EIA REPORT

Copies of Correspondence from
I&APs during Scoping
and EIA Phases

Scoping and Environmental Impact Assessment for the Proposed Development of a 75 MW Solar Photovoltaic Facility (KENHARDT PV 2) on the remaining extent of Onder Rugzeer Farm 168, north-east of Kenhardt, Northern Cape Province

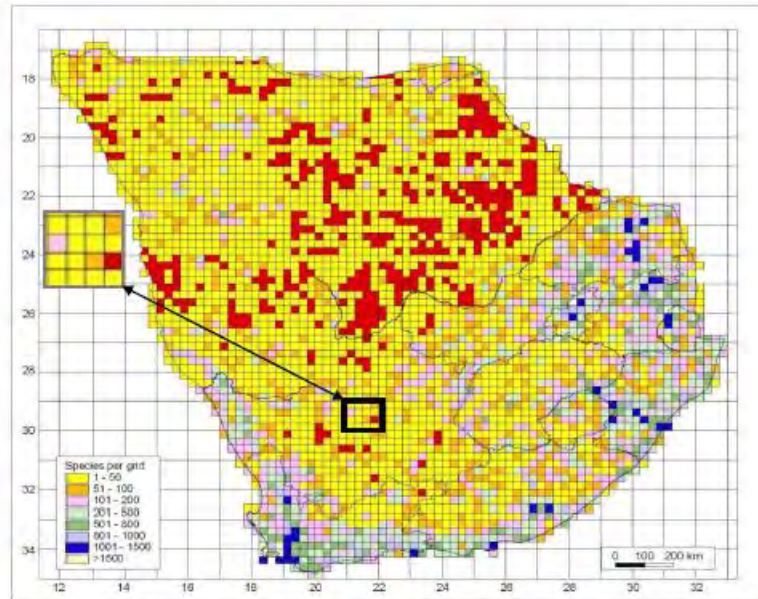
1. It should be noted that the areas where the proposed developments are to be constructed have been historically poorly surveyed, hence extrapolations from desktop studies for specialist's studies will give an incomplete representation of the biodiversity within the area (refer to Figure 2).

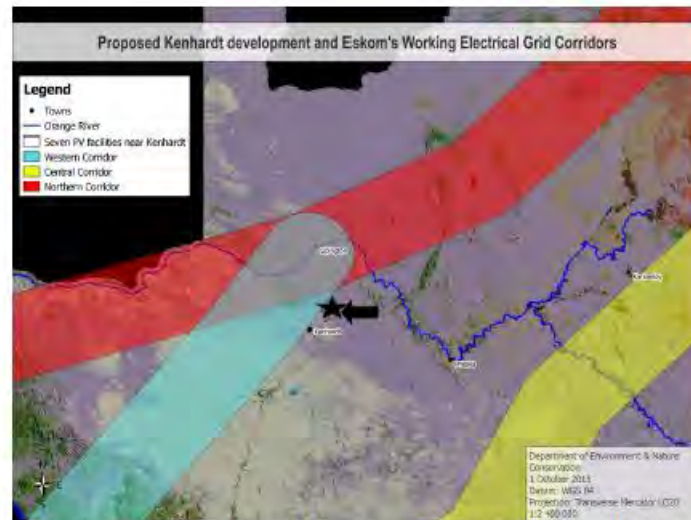
3. The proposed development do not form part of the Strategic Environmental Assessment (SEA) for Eskom's electricity grid upgrades and roll-outs as it falls outside one of the corridors identified by Eskom (i.e. the Western Corridor; one of the five identified corridors; refer to Figure 3). Comprehensive field surveys (within appropriate seasons) should thus be done for this specific area; it didn't form part of Eskom's assessment and the former project's surveys can thus not be used as baseline studies.

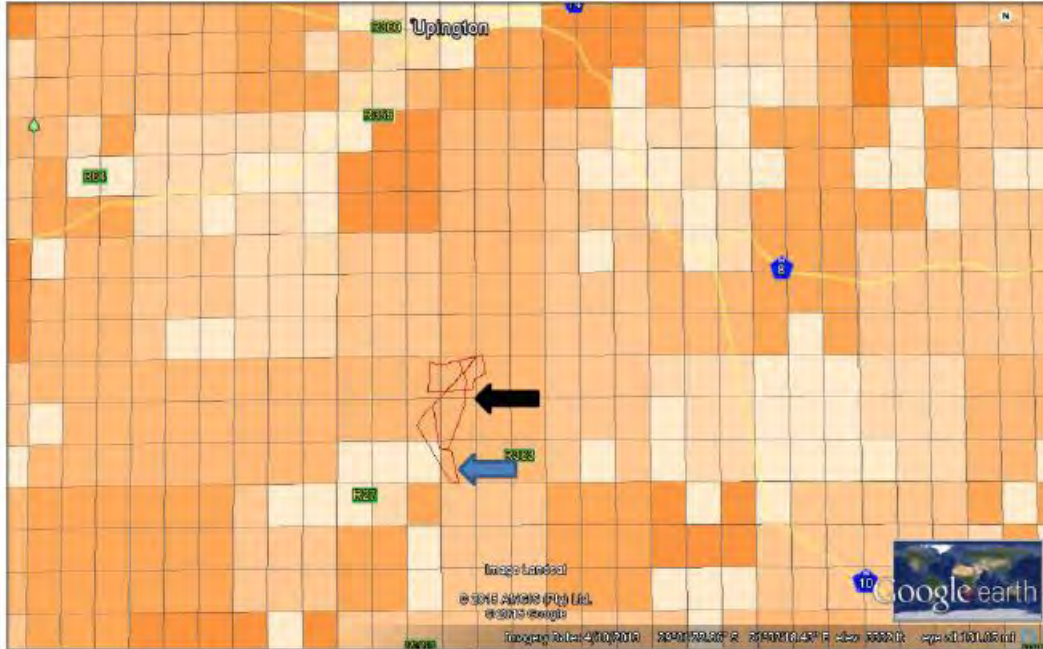
4. The proposed area does not fall within or close to an Important Bird Area (IBA), yet it does resort within a region of grids classified as being sensitive to Wind Farm facilities (refer to Figure 4). The darker the pendent the more sensitive the specific area is to Wind Farm facilities. Closer scrutiny regarding bird studies is thus a prerequisite due to possible impacts of birds on grid infrastructure as by implication local or regional migratory species that move around in response to surface water availability may be at risk from infrastructure collisions. It is also critical to point out that bird data for this area is based on the South African Bird Atlas Project 1 (SABAP1); data published in 1997 and recorded at a much broader scale than the SABAP2 data survey. Evidently, one can conclude that data for this area is outdated. This is specifically highlighted as a point of concern as each of the three PV projects will be separately linked to the Eskom grid through its own set of powerlines.

Figure 5. Several landscape scale connections through drainage lines are evident within the area in question. The two proposed facilities i.e. the Three Solar PV (blue arrow) and Seven Solar PV (black arrow) are to be located in close proximity of drainage lines and wetlands.

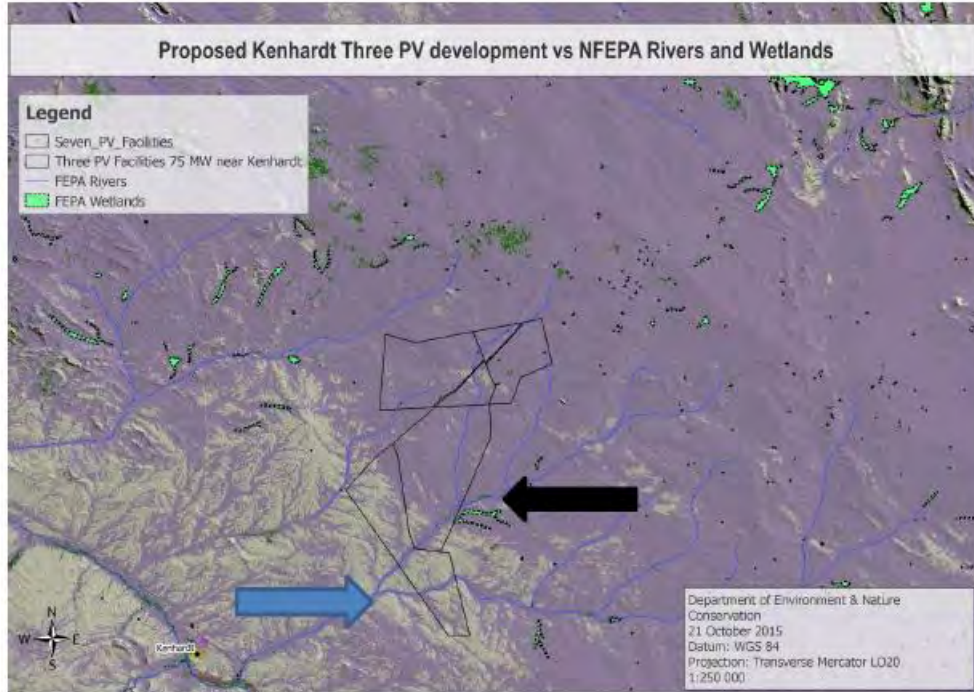
vegetation types is poorly conserved in formal protected areas and extensive areas have been historically overgrazed. As a result, large areas are currently degraded and drainage lines have been modified as a result of anthropogenic impacts. As a result of the extent of the area, impact would most likely be on landscape connectivity as the site is in close proximity of drainage lines and wetlands (refer to Figure 5).
